PD12.13 - No. 2c (Lot 47) Loch St, Nedlands - Attachment 1 - Plans

RE: AMENDMENT TO PLANNING APPROVAL: REF DA12/205 FOR LOT 47, 2C LOCH STREET, NEDLANDS

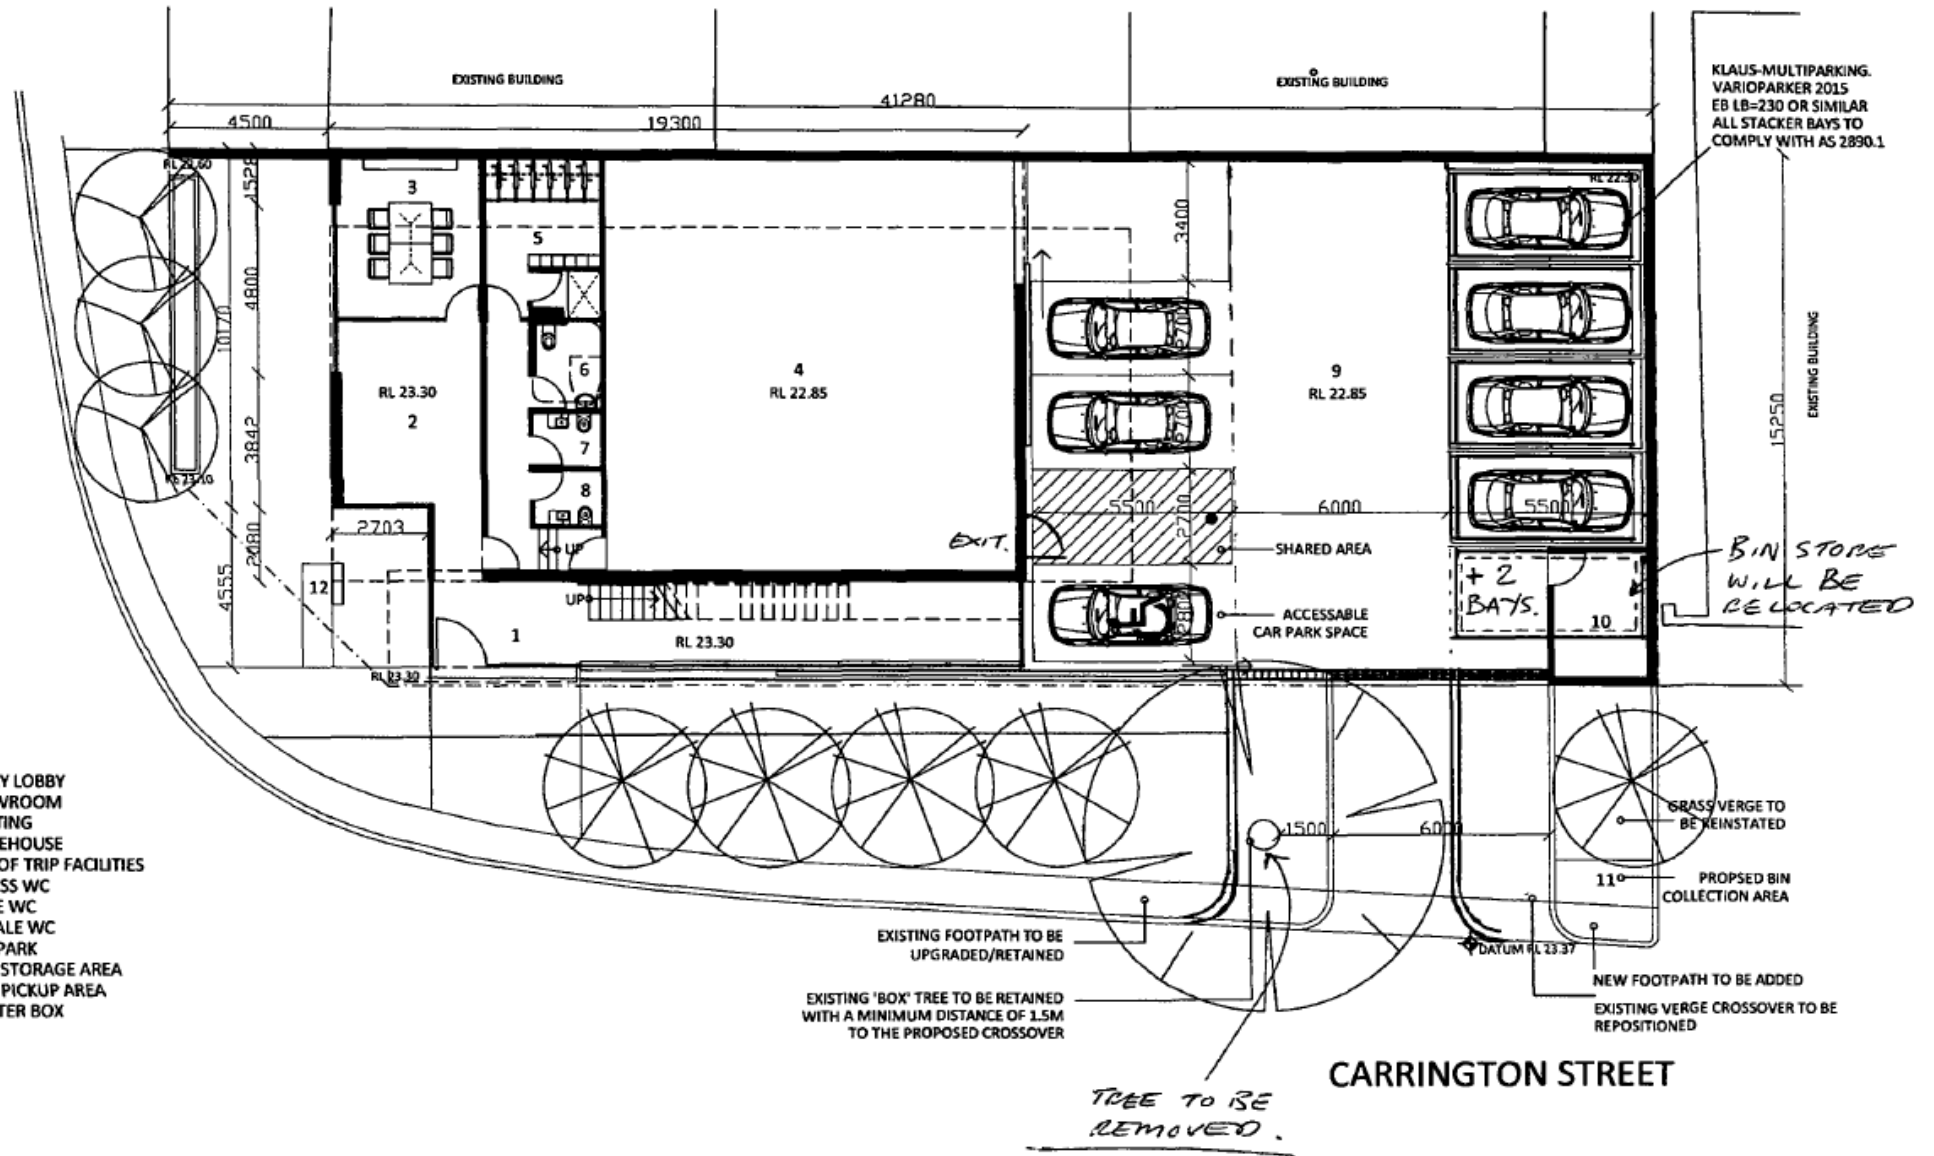
Due to the BCA requirement to include an accessible car parking space, the proposed number of car parking spaces provided on site is now 13 (including 5 stackers). This is a reduction of 1 car parking spaces from the original planning approval. **NB:** 2 of these car parking spaces (bays 12/13) are only able to be reinstated if the crossover is repositioned as outlined under the Verge Use heading below.

This amended design proposes the crossover into the site be repositioned to line up with the car park aisle. It is proposed that the existing 'box' verge tree be removed and replaced by an alternate selected tree to allow for this.

Repositioning this crossover would not only allow for safer manoeuvring in and out of the car parking bays, but it would also allow for an additional 2 bays to be included in the design minimising the parking shortfall mentioned in above.
